UNITED STATES PATENT AND TRADEMARK OFFICE

APPLICATION NO.	FILING DATE	FIRST NAMED INVENTOR	ATTORNEY DOCKET NO.	CONFIRMATION NO.	
10/020,275	12/18/2001	Walter Takeo Yagyu	08200.608	9120	
7590 12/16/2004			EXAMINER		
Liniak, Berenato, Longacre & White			FERGUSON,	FERGUSON, MICHAEL P	
Ste. 240 6550 Rock Spring Drive			ART UNIT	PAPER NUMBER	
Bethesda, MD 20817			3679		
			DATE MAILED: 12/16/2004	DATE MAILED: 12/16/2004

DETAILED ACTION

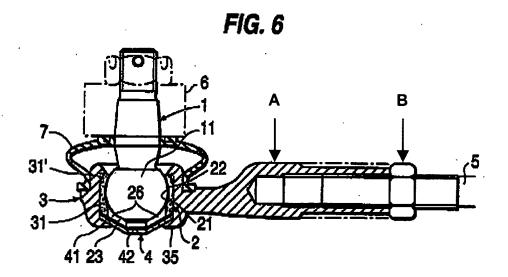
As to claim 1, Shimizu et al. disclose a tie rod comprising a stem 5 provided at its ends with ball joints 3 each composed of a metallic ball joint box A (box A of ball joint 3 has a metallic cross-hatching; Figure 6 reprinted below with annotations), a bearing 2, a protection cover 7 and a ball pin 1, the tie rod having the function of fixing pieces and components of a mechanical system between themselves, providing to them angular and rotational movement, supporting the strains concentrated therein, wherein the stem of the tie rod is combined with components of the metallic ball joint box (Figure 6).

As to claim 3, Shimizu et al. disclose a tie rod wherein ball joints 3 are attached to the ends of a stem 5 by means of a thread on the body of the stem and in the ball joints' boxes A, making the tie rod a tie rod with variable length, the adjustment of its

length and the locking of the tie rod being provided by nuts **B** provided on the threads of the stem and that are tightened against the boxes of the ball joints (Figure 6).
